# VM6250

CA.DT.A66-5e - May 2017

VM6250 Hardware Release Notes

### ▶ Component Height on Bottom Side of the Board - CRP3707

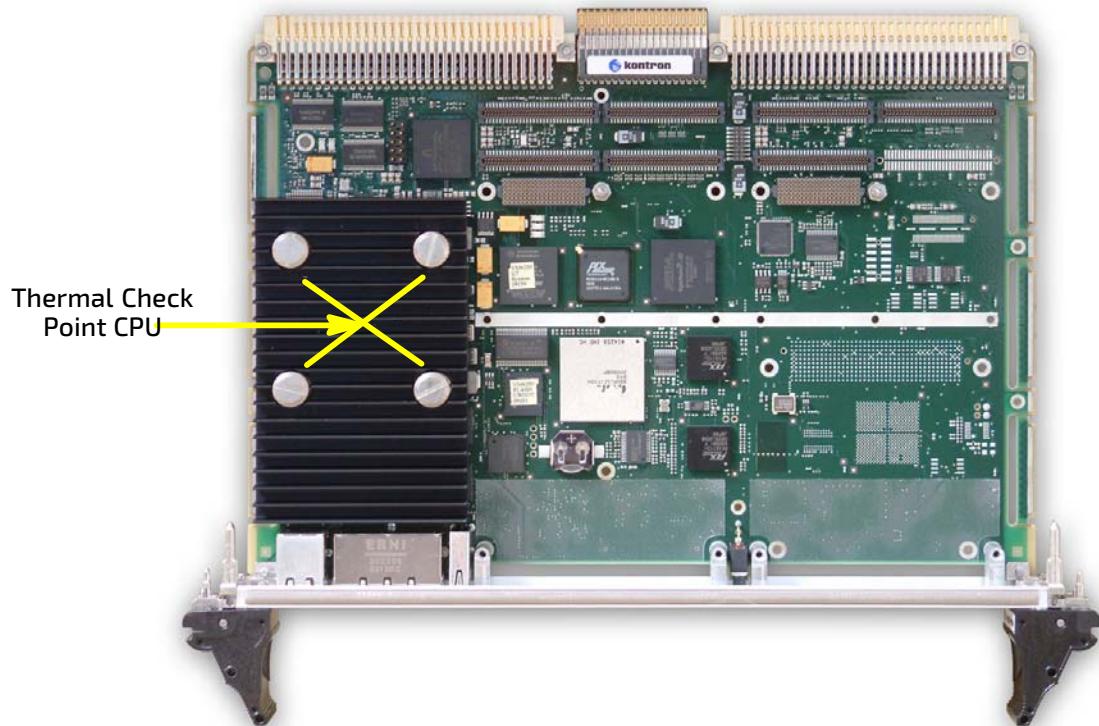
The Ethernet magnetics are slightly higher than the maximum height as specified by the VME standard (max. violation of 0.04 mm).

No problem have been reported. Nevertheless, it is recommended to insert the boards in a rack starting from the higher slot number and extract them starting from the lowest slot number. This good habit also protects EMC gaskets located on the front panels of all VME boards.
